Docket No. 52-002

PROJECT: CE System 80+

SUBJECT: PUBLIC MEETING OF DECEMBER 2 and 3, 1992, TO DISCUSS THE CE
SYSTEM 80+ SEVERE ACCIDENT SUBMITTAL

Figure 2-9. ALWR Combustion Potential.

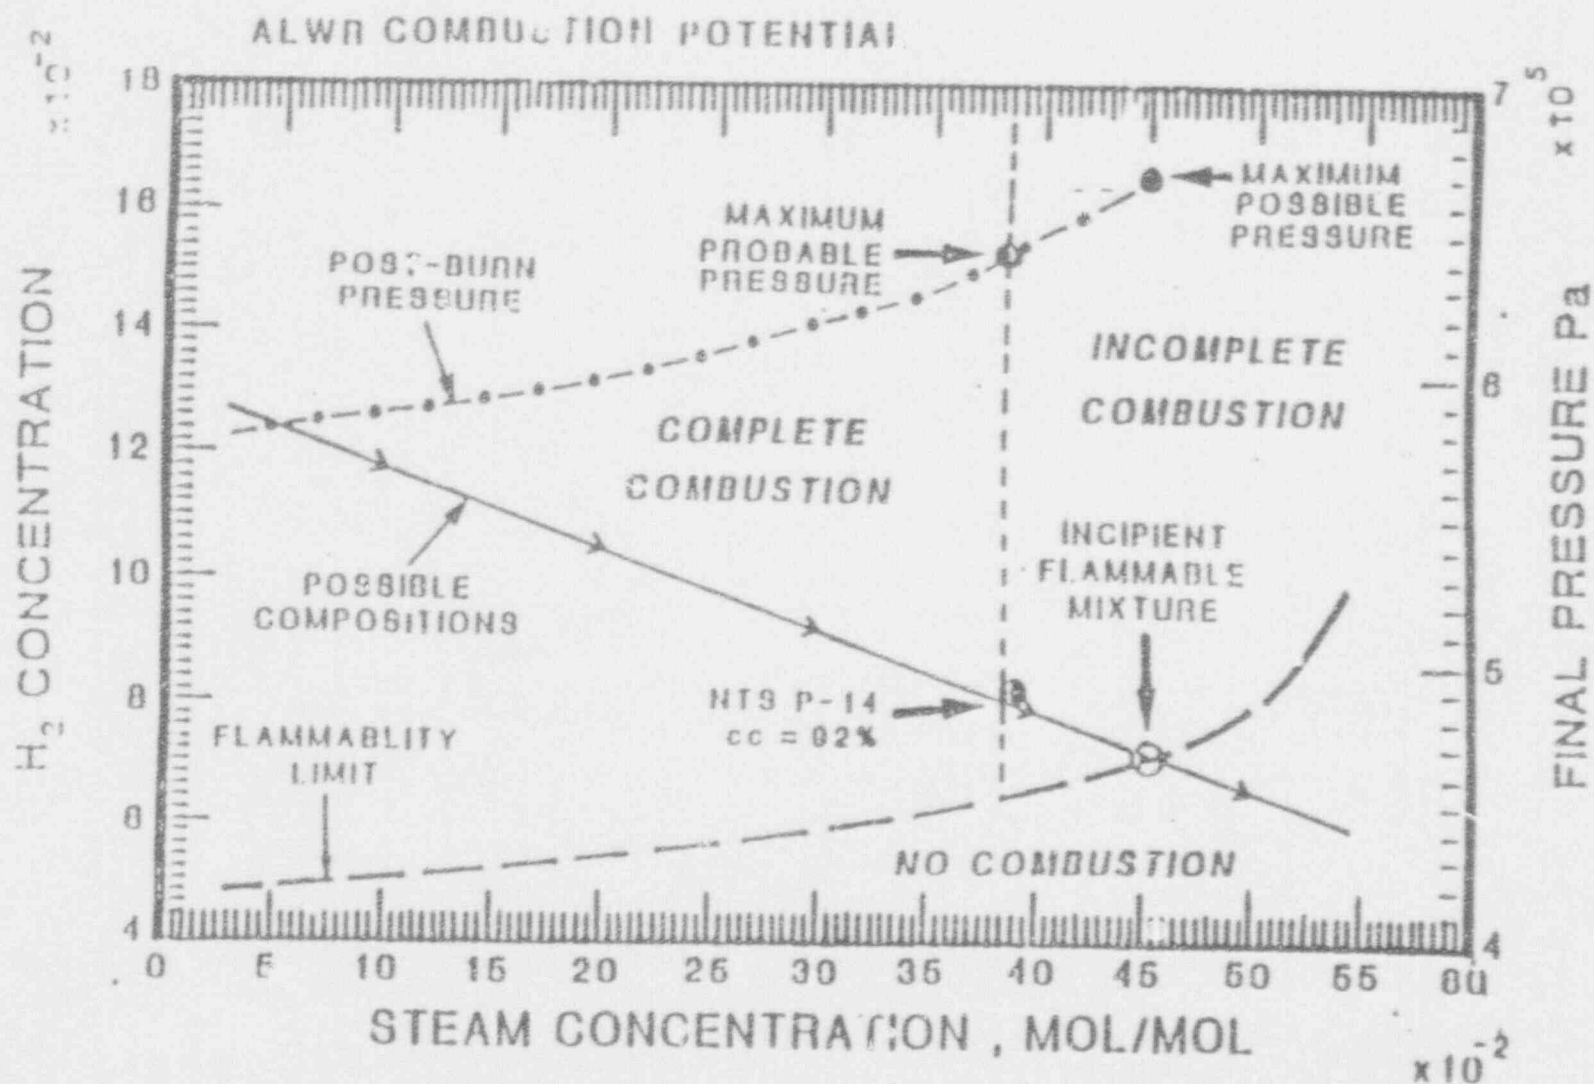
ABB-CE supported their approach by comparing their calculated values against experimental data. They concluded that their calculated values bounded all experiments and was therefore conservative. Figure 4.1-2 was the focus of the discussion. It is used by ABB-CE as confirmation of the actual calculations performed by them. It was noted that the presence of steam seems to indicate that the peak pressures would be about 15 psi higher than dry air.

48. Further discussion of Figure 4.1-2: ALWR Combustion Potential.
49. We would like to review the analysis that establishes for 100% Metal Water Reaction complete AICC hydrogen burns result in peak containment pressures of about 140 psia. (4.1.3.1.4, page 4-32)

PRELIMINARY RESPONSE TO ITEM 48

The above example can be generalized to find the maximum post-combustion pressure for an ALWR containment. As steam is added to an atmosphere of air and hydrogen, the initial pressure and final post-combustion pressure both increase. However, eventually, the mixture becomes inert due to steam addition when the flammability limit is reached. An approximate method is derived in Appendix A, which can be used to determine final pressures resulting from complete combustion of 13% H_2 on a dry basis at various system steam pressures. A calculation using steam table values is presented here. The flammability limit of diagram of Figure 2-2 can be used to determine whether these mixtures are flammable. The maximum final pressure for a 13% dry basis H_2 plus steam mixture which is possible in a containment under initially saturated conditions is defined for the flammability limit. Containment conditions will not be superheated because such a condition is only possible when dry core debris exists in the containment, a situation precluded by the EPRI ALWR debris coolability requirement (see Section 3.1).

The results of this thermodynamic equilibrium calculation for possible containment atmospheres are shown in Table 2-5 and Figure 2-9. The final pressure increases as the initial temperature increases because the initial pressure must increase due to steam addition, but the pressure ratio decreases and is seen to be highest for the dry case (300°K). The maximum theoretical pressure in a containment following a burn is 6.5 atm based on the flammability limits. However, also shown in Figure 2-9 is the anticipated boundary between the complete and incomplete combustion regimes. The maximum probable pressure is thus about 6.4 atm. When more steam is present, incomplete combustion would be expected and the final pressure would be less than this value.

Figure 2-22 Hydrogen concentrations in the modified IRWST. (Steam generator enclosures and upper compartment during a high-pressure SBO with blockage and no burns.)

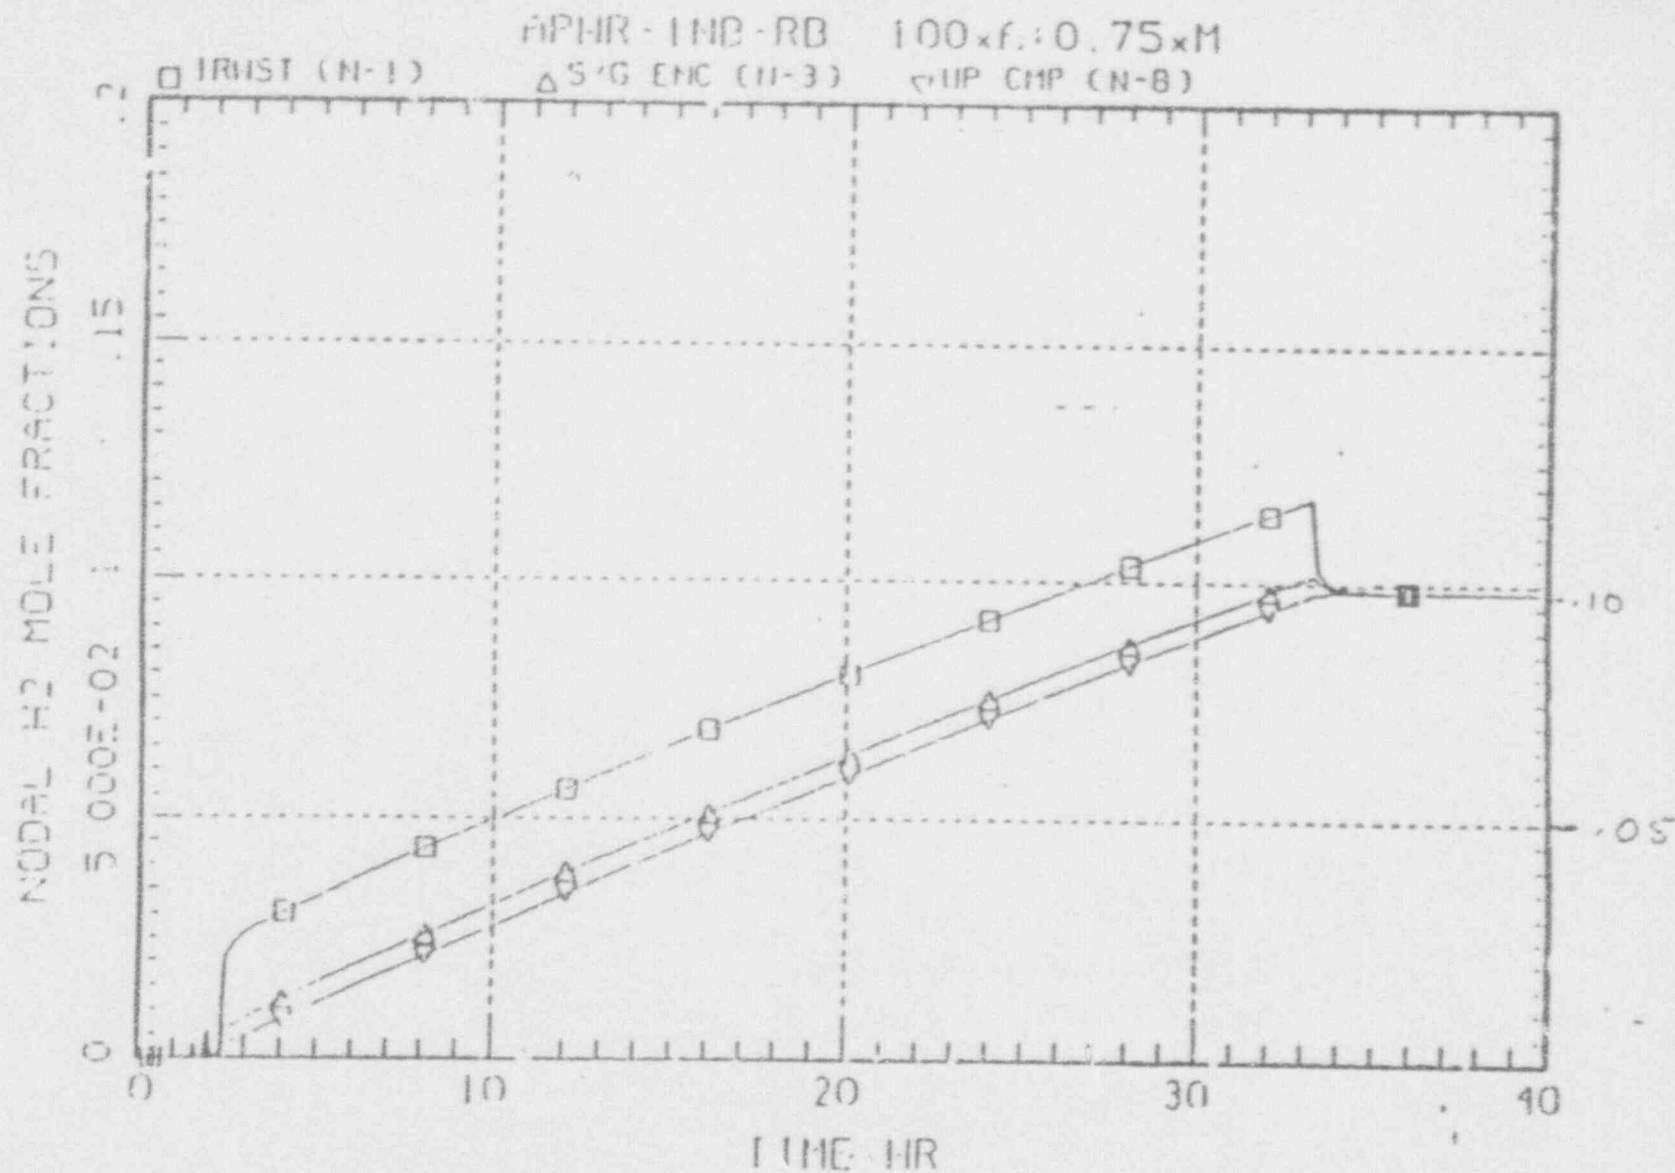
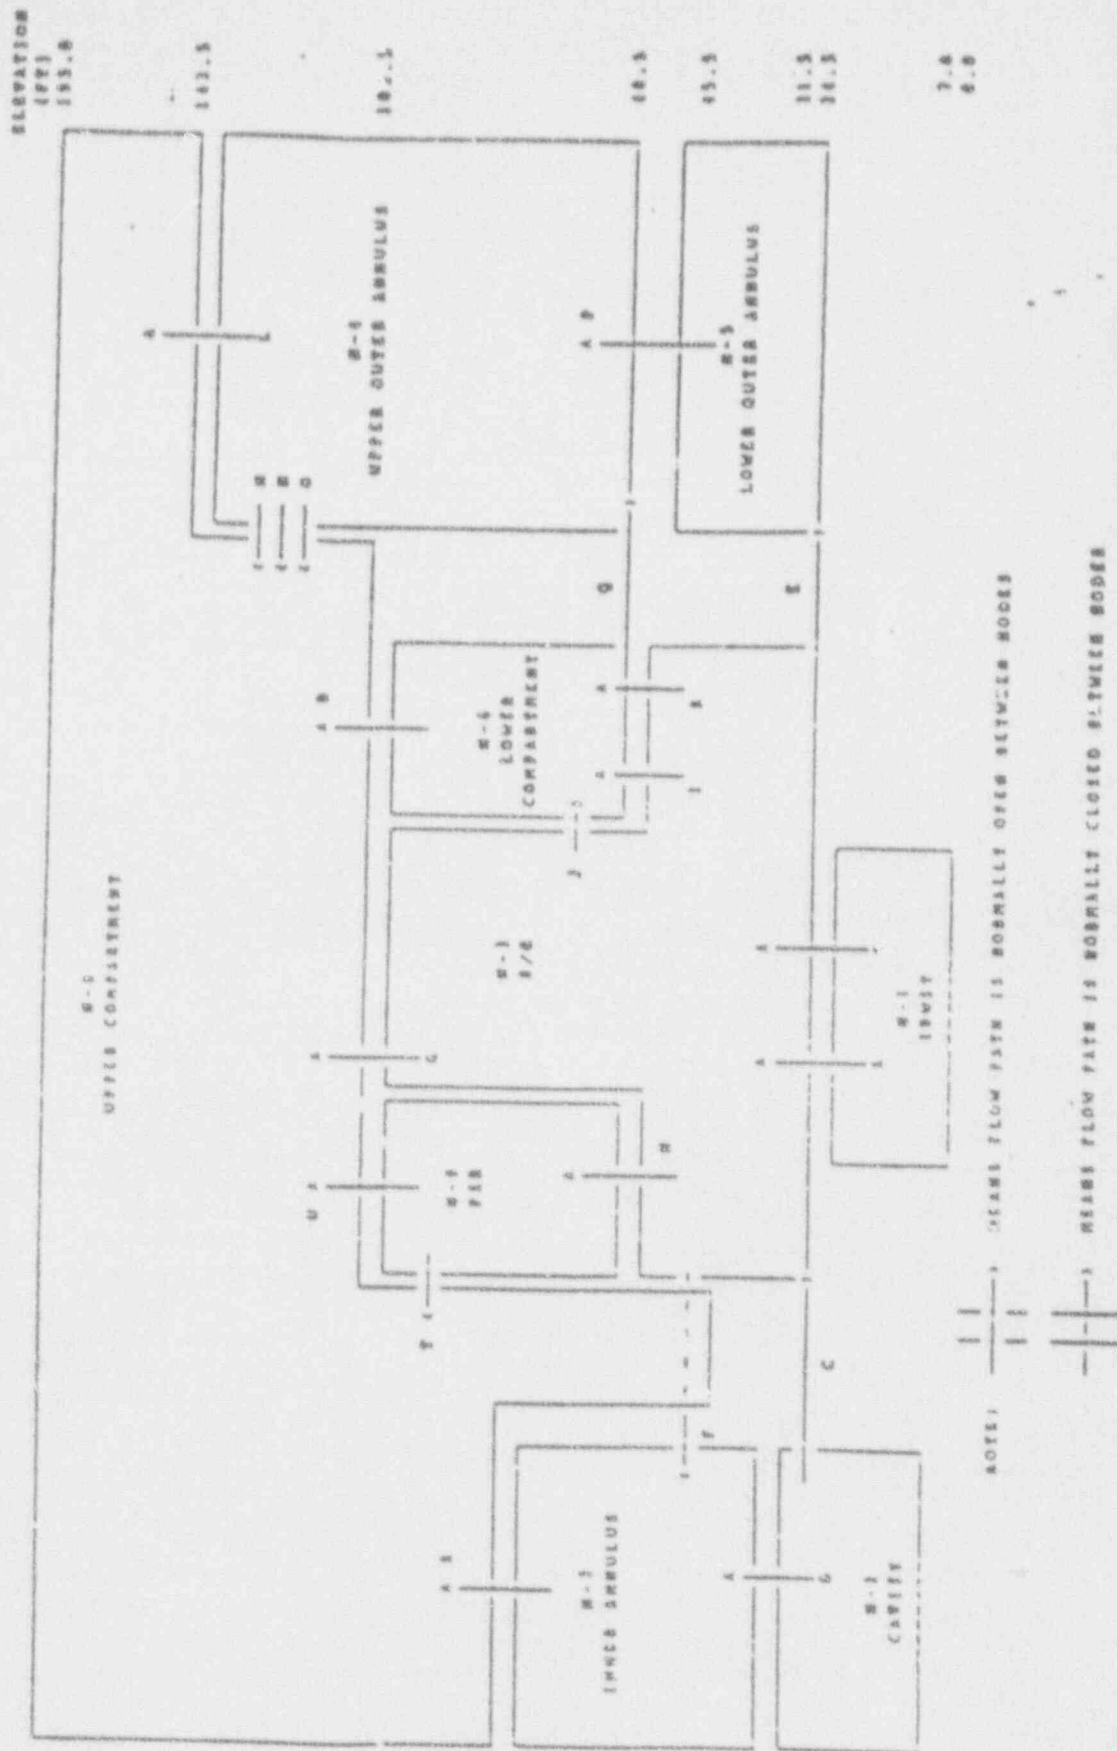
ABB-CE reported that the approach used the guidance of a advanced light water reactor document cited in Question 48. In any case, ABB-CE intends to redo the MAAP calculations. The staff pointed out that local hydrogen concentrations predicted by lumped parameter codes such as MAAP are a strong function of the volume of the nodalization scheme.

While ABB-CE did not agree nor disagree with the limitation, they indicated that the maximum hydrogen concentration was a minor point since System 80+ relies on igniters to limit concentration. The staff reiterated the point that the 2-percent value is an artifact of the node chosen in the MAAP run. In any case, hydrogen igniters will be located immediately outside the IRWST. In addition, ABB-CE will provide a discussion of why high concentrations in the vicinity of the IRWST are not possible. As part of this, ABB-CE agreed to review the mass and energy releases from the IRWST for selected sequences to identify potentially rich hydrogen concentrations. These hydrogen conditions include loss-of-feedwater, station blackout, and feed-and-bleed sequences. This will be submitted as part of the January 21, 1993, package.

PRELIMINARY RESPONSE TO ITEM 50

See Attached Figures ⁵⁰from DOE/ID-
